V2500-A1/A5/D5 SERIES PROPULSION SYSTEMS SERVICE BULLETIN

This document transmits the Revision 2 of Service Bulletin V2500-ENG-75-0108.

V2500-ENG-75-0108

AIR – ACTIVE CLEARANCE CONTROL (ACC) – INTRODUCTION OF A PERISEAL HOUSING WITH
INCREASED INNER LIP DIAMETER

Figure 2 - Rework Limits of Periseal Housing 01-630 and 01-730

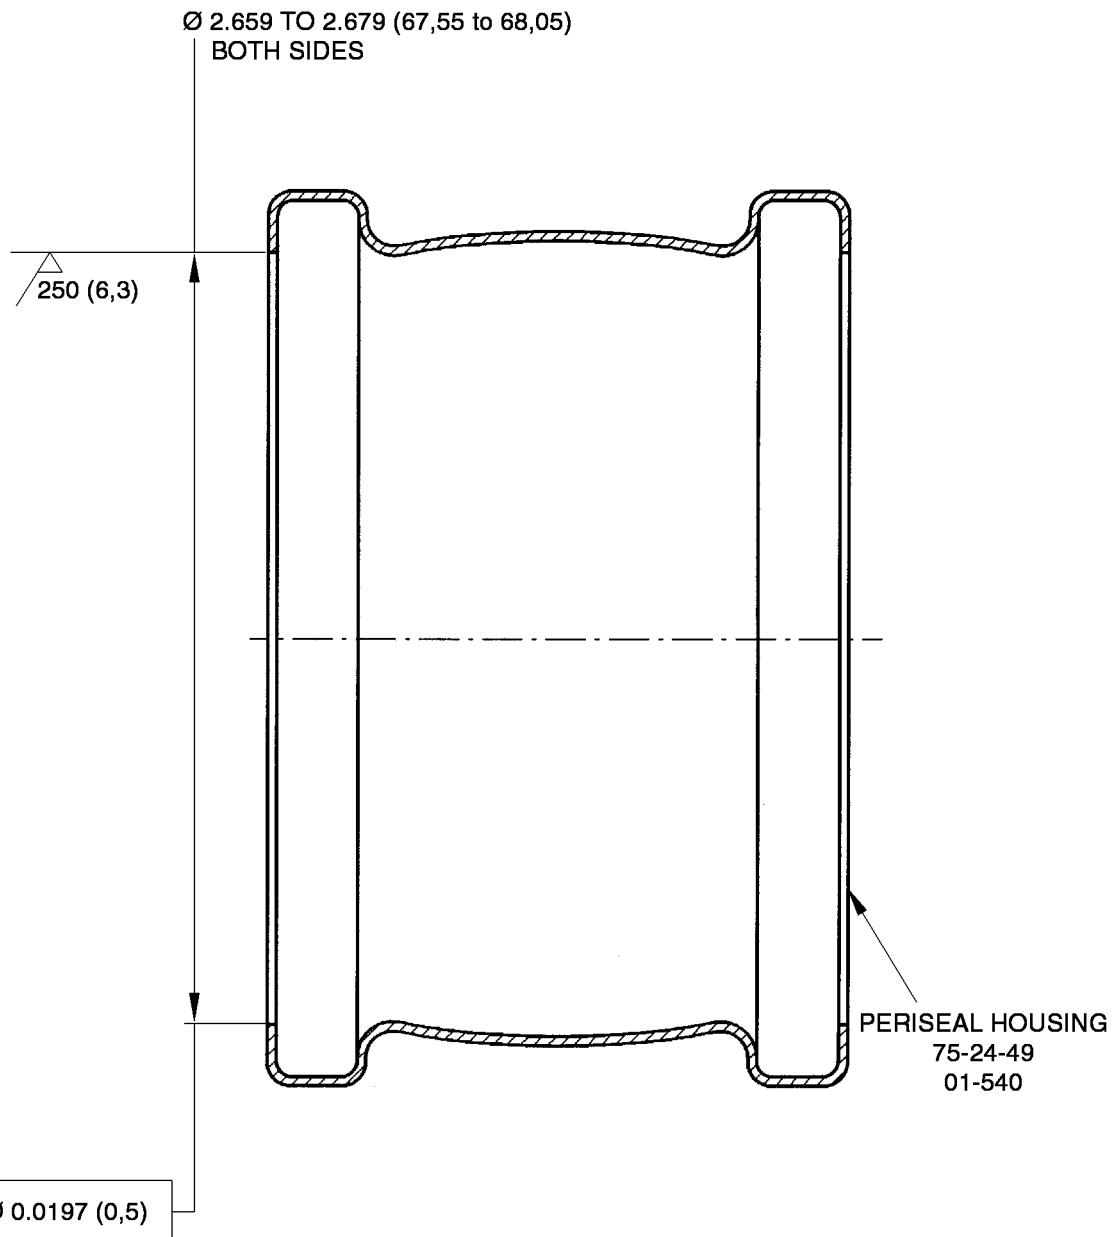
| (4) Machine the periseal housing. | Refer to Figure 1 or Figure 2.
| (5) Examine the machined area dimensionally. | Refer to Figure 1 and Figure 2.

| (8) Reidentify the periseal housing. | Reidentify adjacent to the existing part number as given below.

NEW PART NUMBER	OLD PART NUMBER
3A3014	3A0562
3A3017	3A0188

Figure 1 – Rework Limits of Periseal Housing 01-540

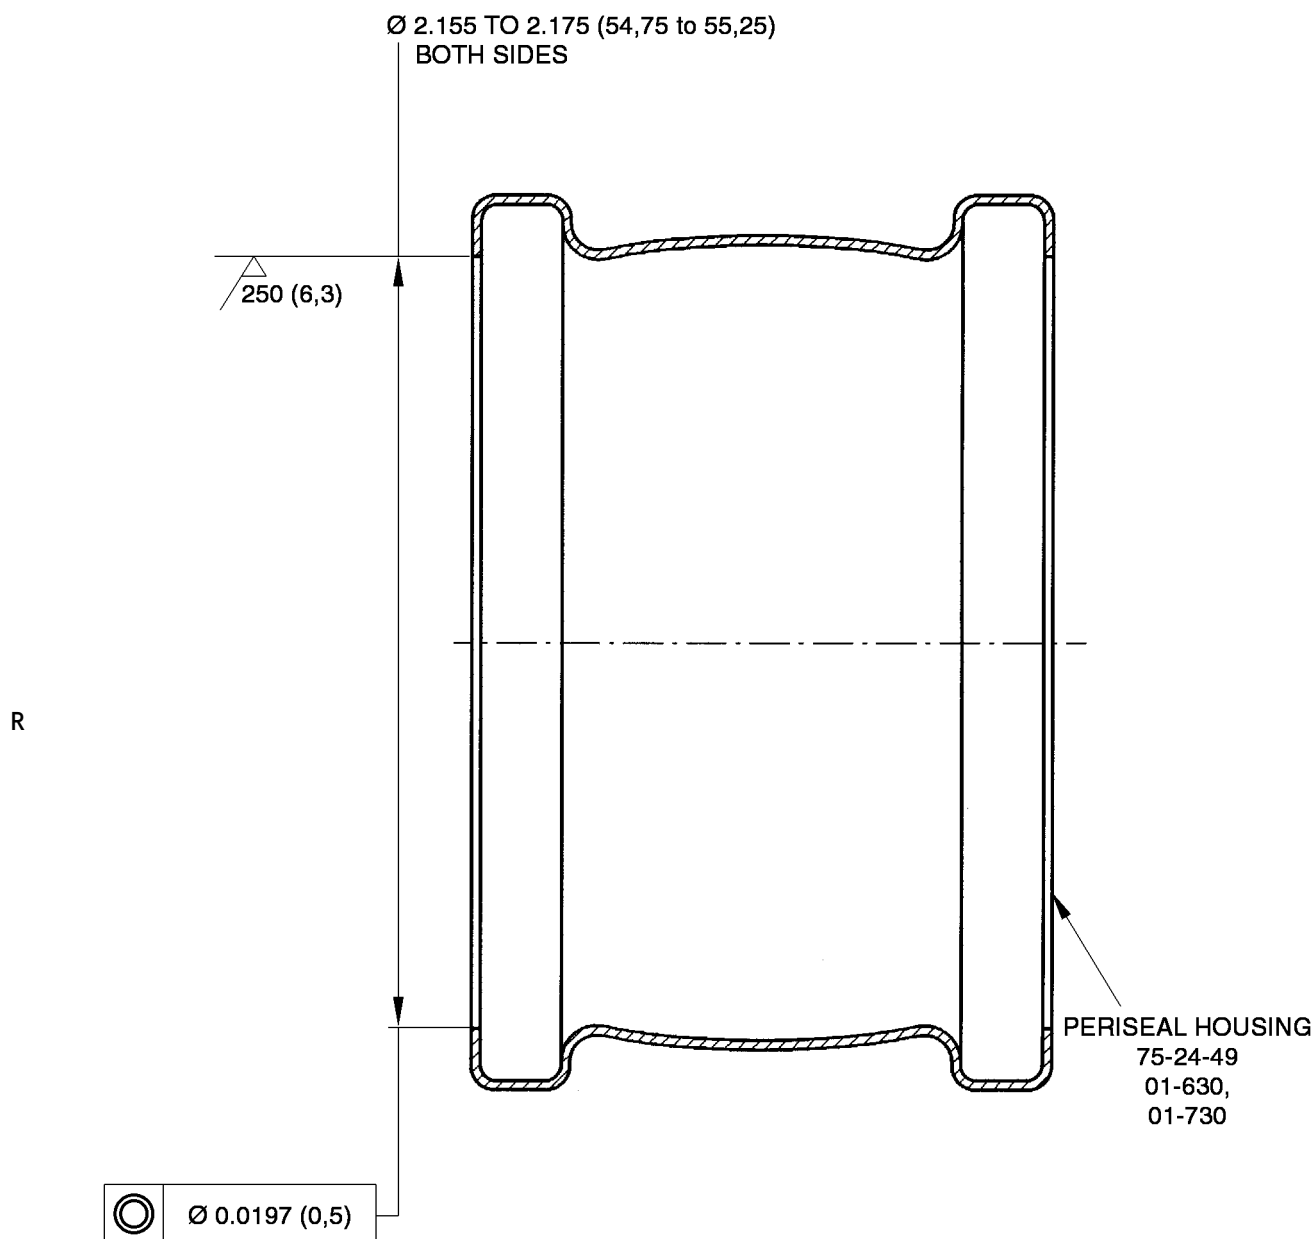
Due to shrinkage of the periseal seal ring as a result of high temperature exposure, contact between the inner lip diameter of the seal housing and the ACC connector tube end, upon which it sits, can occur. By increasing the lip diameter by 0.08 in. (2 mm), the problem can be obviated. A leakage check has been carried out successfully to confirm this.

Introduction of new periseal housing with increased inner lip diameter by 0.08 in. (2 mm). For rework instructions of existing parts refer to Section 3. "Accomplishment Instructions" of this Service Bulletin.
